Clause 47 Report

Comment Resolution

#37: XAUI Return Loss

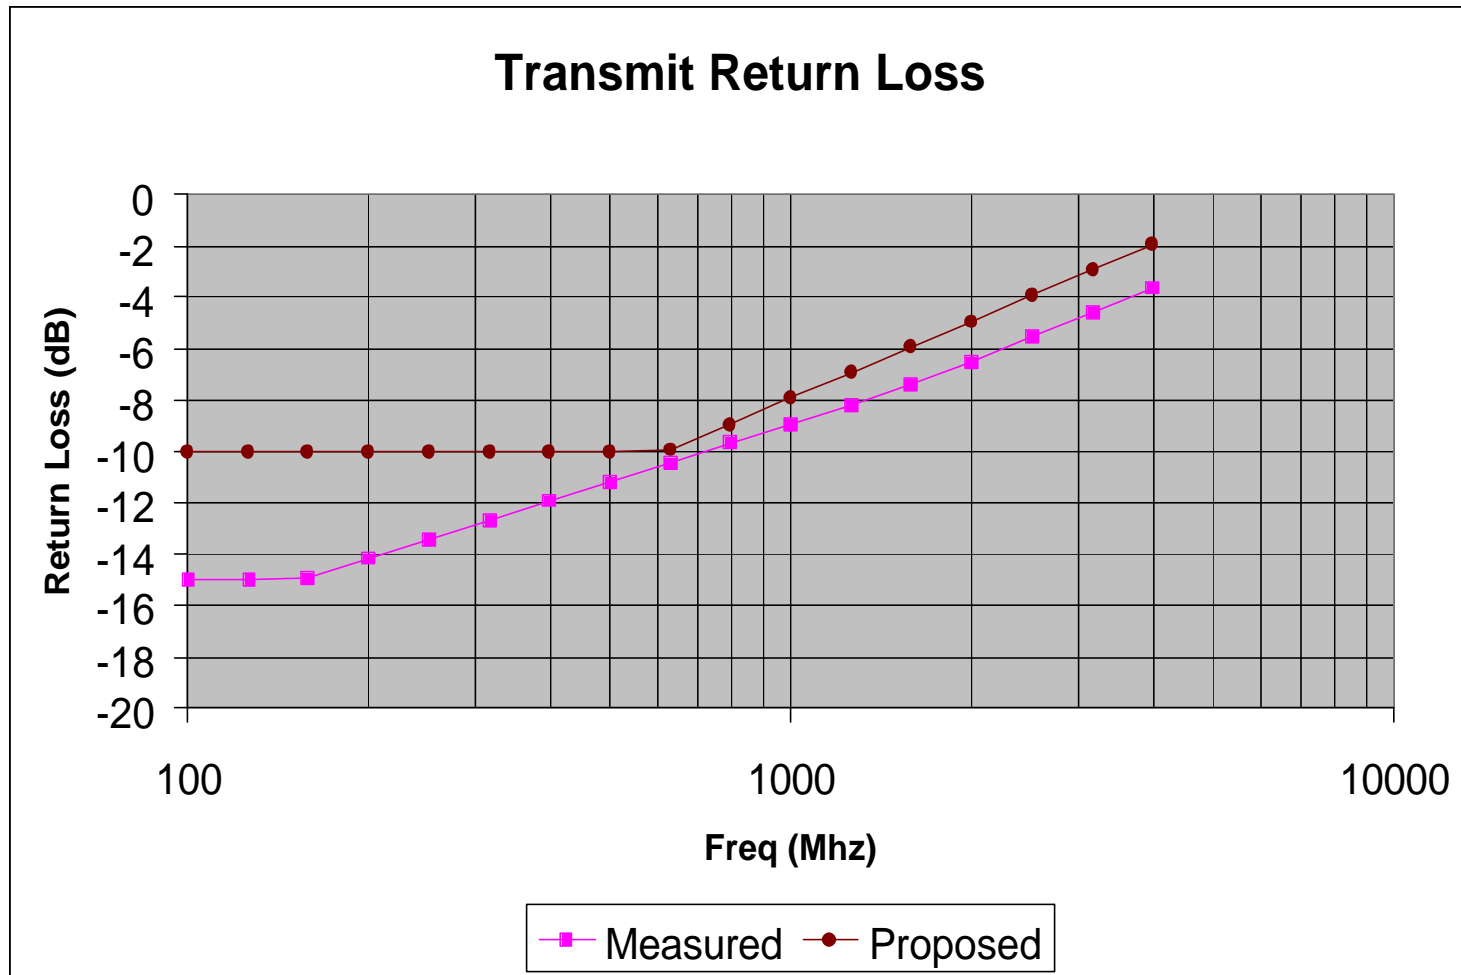
- Resolved all 10 comments
- 4 TRs, 2 on Return Loss, 2 on Jitter Distribution
 - #37: Transmit Differential Return Loss
 - AIP, Satisfied, Resolved with new equation to replace text
 - #4: Rx Return Loss S/B = Tx Return
 - No problem provided with Rx Return Loss
 - Rejected, Unsatisfied
 - #286: Template (mask) alignment/jitter distribution
 - AIP, changed “p-p” to “from the mean” values
 - #287: Template (mask) alignment/jitter distribution
 - Accept

#37: Equation

$S_{dd11} = -10 \text{ dB}$ for $312.5 \text{ Mhz} < \text{Freq (f)} < 625 \text{ Mhz}$, and
 $-10 + 10 \cdot \log(f/625) \text{ dB}$ for $625 \text{ Mhz} \leq \text{Freq (f)} < 3.125 \text{ GHz}$

- Made the corresponding change to the "Differential output return loss minimum" parameter in table 47-1, Driver Characteristics.
- Note that the return loss spec embodied in the equation above is different from that currently specified in D4.0.
- The impact of loosening transmitter return loss results in an increase in return loss contribution to deterministic jitter from 0.03 UI to 0.049 UI. This increase is considered to meet the existing XAUI jitter budget.
